NASHPA COMPRESSION FACILITY PROJECT

Tender Enquiry No.: PROC/FC/CB/PROJ/NASHPA-3268/2018

PRE-BID CLARIFICATION # 18

One of the bidder has asked following queries, OGDCL/ENAR responses are as follows:

DRAWING TITLE: **ELECTRICAL SINGLE LINE DIAGRAM FOR MCC**
REV. SCALE SHEET
00 ~ 1 OF 4

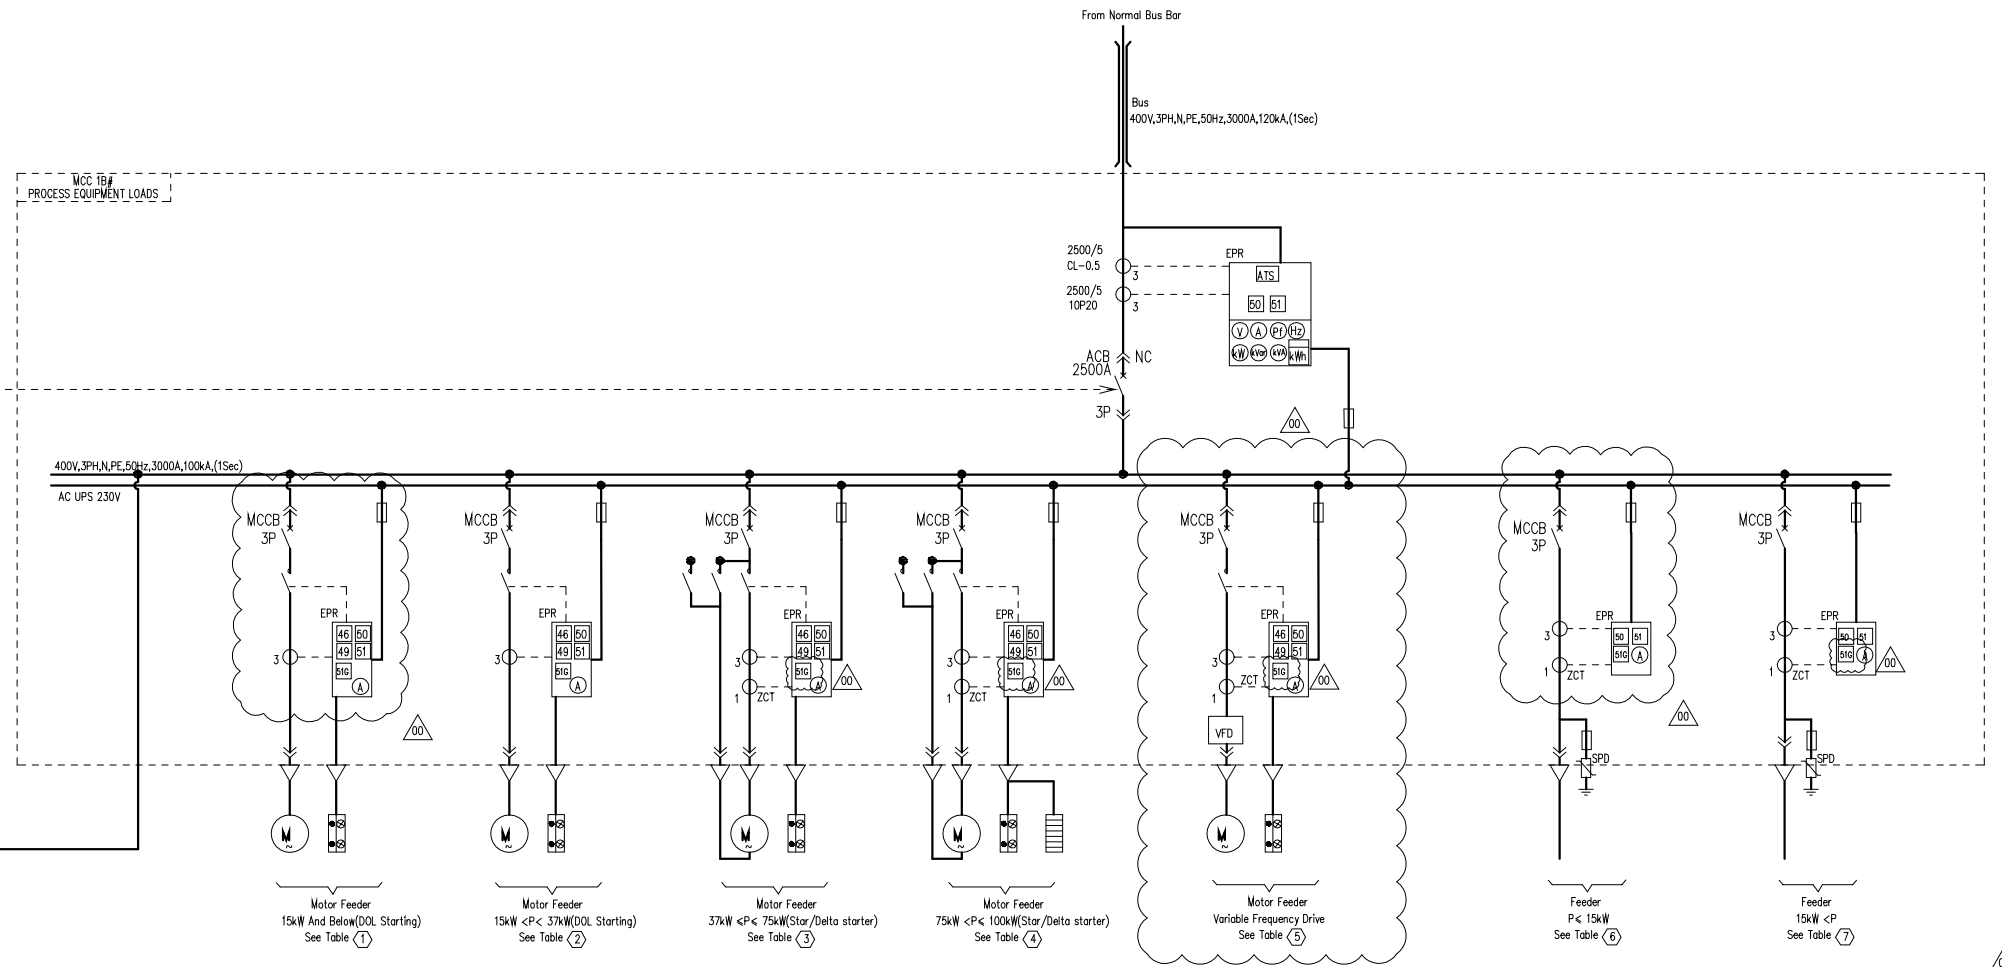
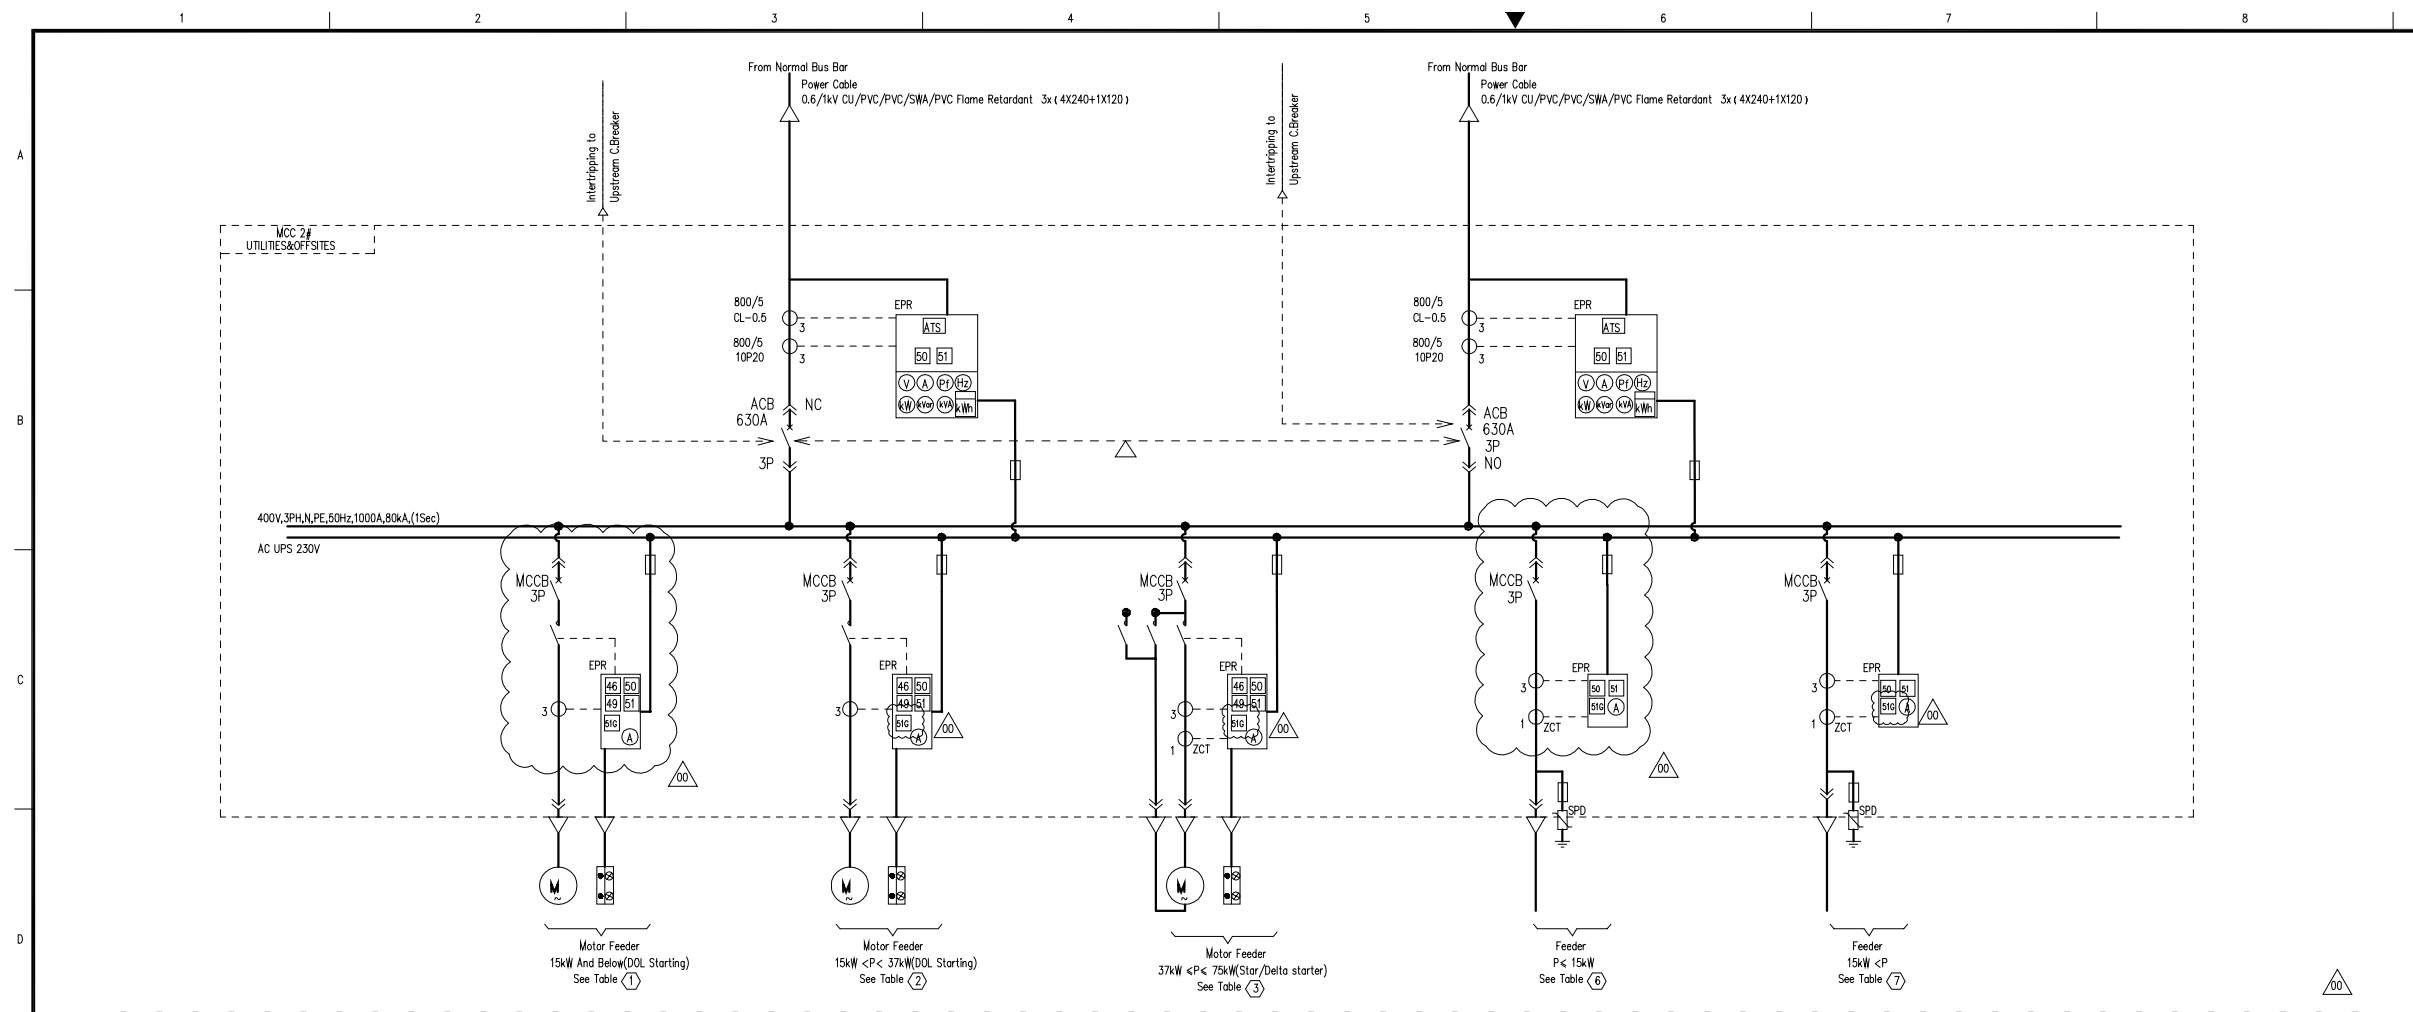
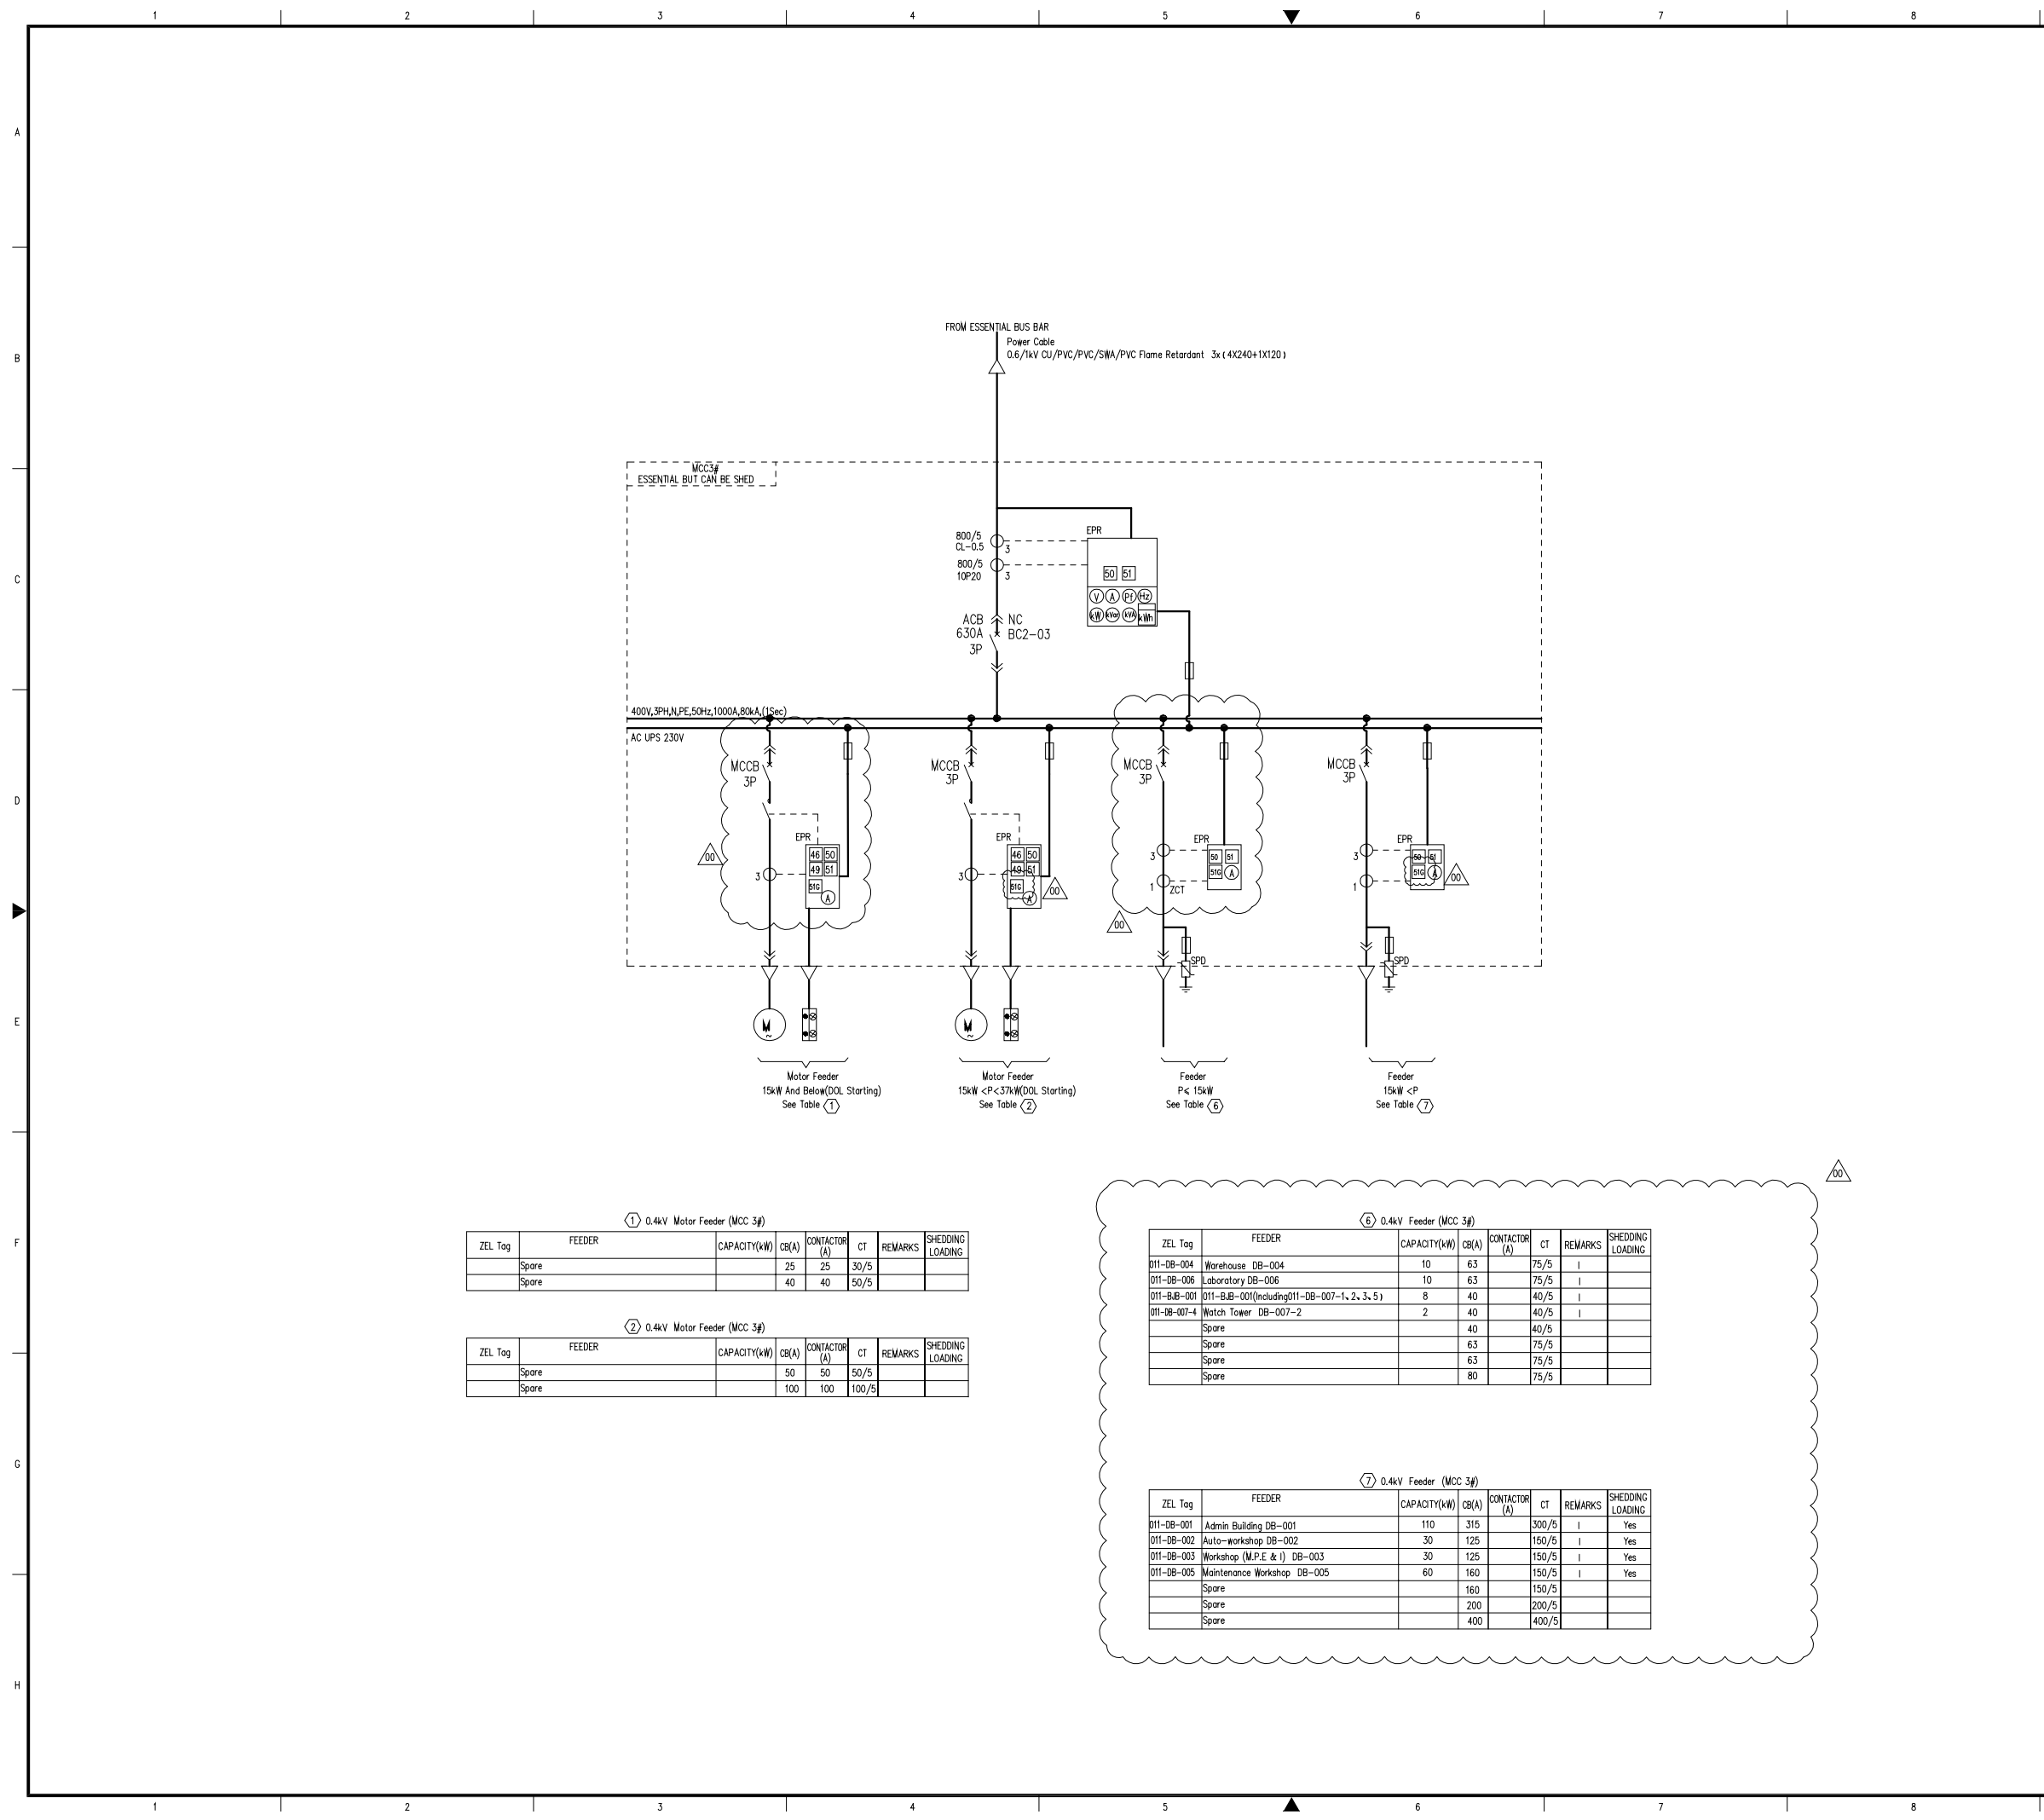
21	<p>Section 4.8 (e) of Scope of Work Page 28 of 106</p> <p>Welding Industrial sockets: 'Client to provide the Power Layout of the existing plant in which the welding industrial socket outlets are shown. This is required for suitable placement of new outlets. Client is also requested to confirm the requirement of Maximum radius that need to be covered by one welding socket. we understand that this radius should be 60m max. Client is also requested to provide the Single Line drawing of Distribution board which is feeding the power to the existing welding sockets</p>	<p>EPC Contractor to finalize the location of industrial sockets during the detailed engineering and cable routing layout for general area will be updated accordingly. The outlets shall be located such that the maximum length of lead required to reach any outlet is not more than 30 meters (in case of utility socket if required) and 50 metres (in case of welding socket).</p> <p>Power supply shall be feed from MCC#2, refer attached drawings.</p>
